Change Nr,Title 20004518,CHANGE BOX QTY TO BE 32 PCS
Date of issue 26.11.2018

Change the quantity per box from 112 to be 32 PCS/BOX

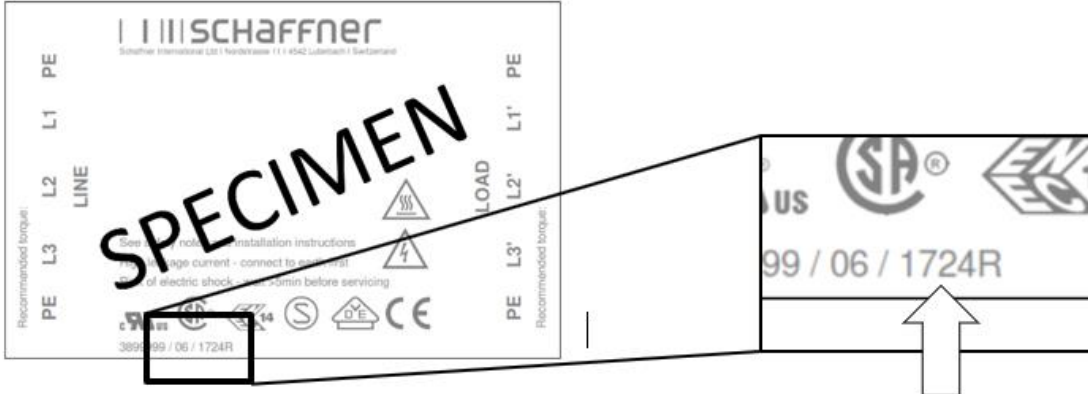
There is no visual difference of the products.
Size of box and quantity per box will change to a smaller box.
